STATE OF OREGON  
Department of Environmental Quality

Owner: MAUREEN K MCDOUGALL Permit Number: 12-189578-SP  
Location: 3722 NE MAYWOOD PL

**ON-SITE SEWAGE DISPOSAL/ALT PERMIT**

12-189578 SP New tank & D.F. (seepage trenches)  
to replace failing cesspool.

**Section 3: As-Built Plan of the Constructed System** - Indicate the direction of North and show the locations of all wells within 200 feet of the system.

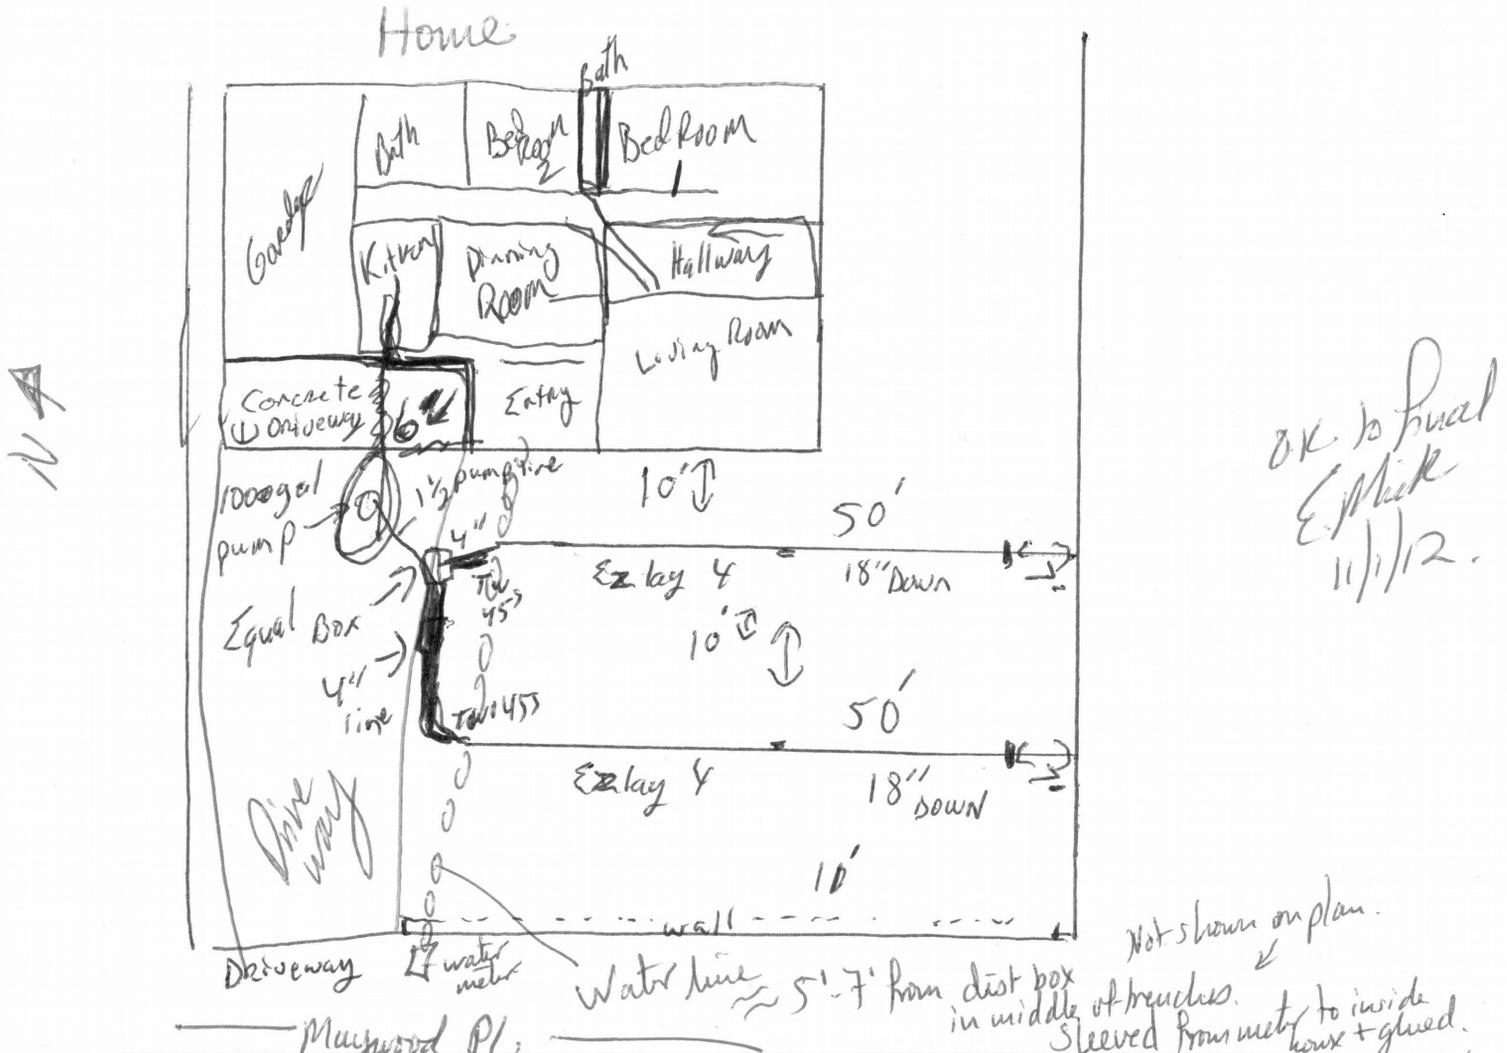
2 x 50' EzFlow seepage trenches - 4 bundles top line had light leak at coupling. Once bedded, it will be at proper elevation. Please bed properly. D-box w/ traffic rated lid as well.

Water line is running through middle of drainfield. It was sleeved w/ 2" SCH 40 that was glued from meter to house + was glued to shrink gasket around house. Owner is aware + accepts risk.

- ET + PT from C.O.T approved - inspection shows onsite as built rec'd + is good.

TANK SECTION

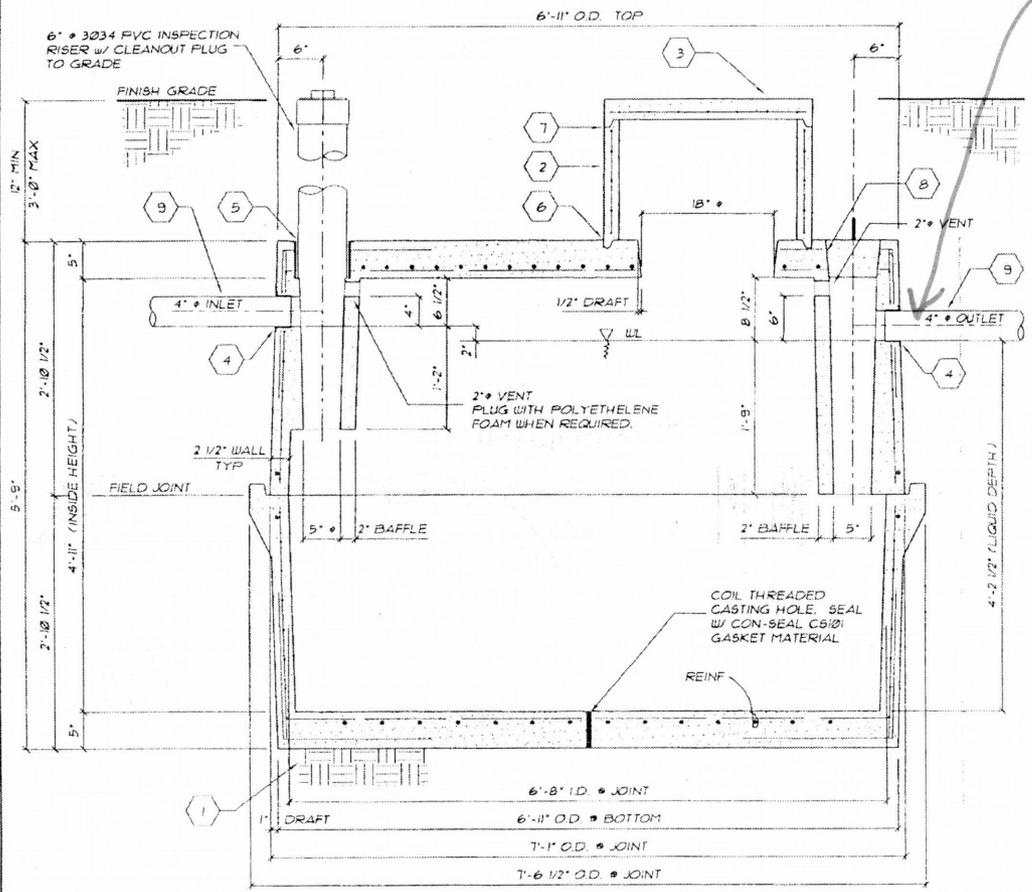
*Converted to a dosing, see  
e-mail  
& notes  
on p. 2*

to be capped & filled w/ concrete

to convert to a dose tank. @ 2" less w/ inlet now 2" higher will be reflected in float setting changes.  
 Conversation of Jan from Michael's.

*Erin,  
Per our second conversation I will pour the outlet baffle of my 1000 gallon H2O (traffic rated) Septic Tank full of concrete, making the outlet water tight. By blocking the outlet baffle this will turn the 1000 gallon H2O Septic Tank into a 1000 gallon H2O Dosing Tank. The only difference will be the inlet will be raised by 2" from a standard 1000 gallon H2O Dosing Tank and we will adjust the float settings to correct this. Please see the attached specs on both tanks.*

*New float settings are as follows:  
Alarm on 15"  
Pump on 17"  
Pump off 21"*

*This is measured from the outside top of the tank down.*
